Post Hearing Submissions and Response to Deadline 4 Submissions ELMESTHORPE PARISH COUNCIL 9th February 2024

3. HGV Route Management Plan and Strategy: 17.4B Hinckley NRFI HGV Route Management Plan and Strategy

Figure 1: Main HNRFI Site location

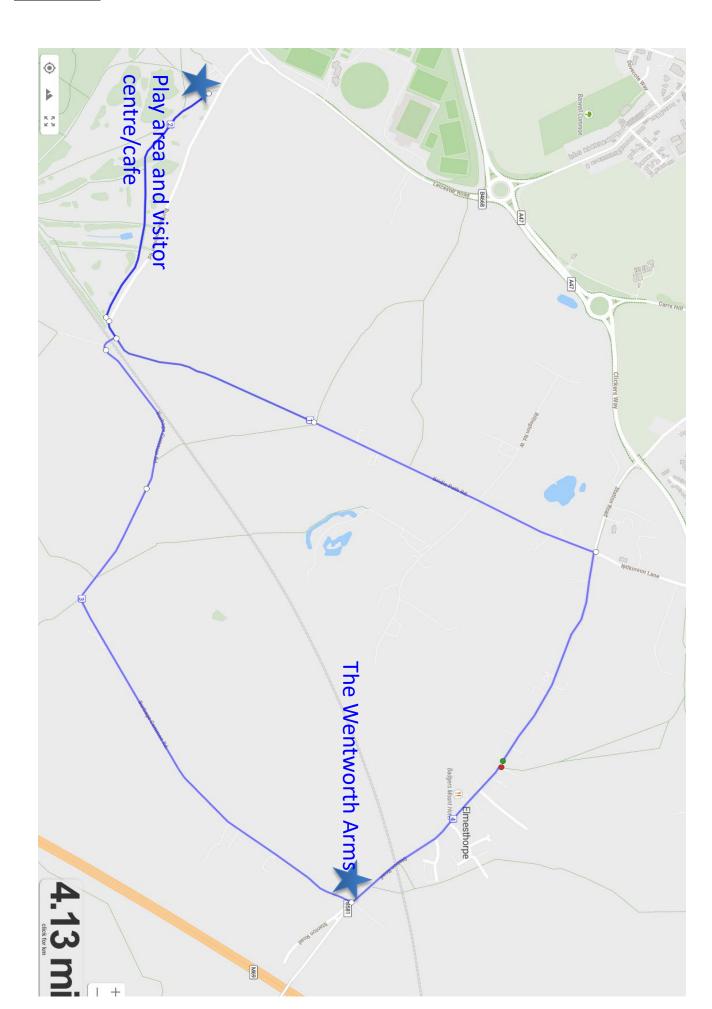
- 3.1. Within the HGV Management Strategy (and in other documents), Elmesthorpe is consistently omitted from maps (see appendix 1) and descriptions of the site. Paragraph 2.19 describes Elmesthorpe's existence on the B581 as 'intermittent residential frontage.' The village is incredibly close to this site and the reporting of the site location is disingenuous.

Edited to annotate Elmesthorpe on the map:
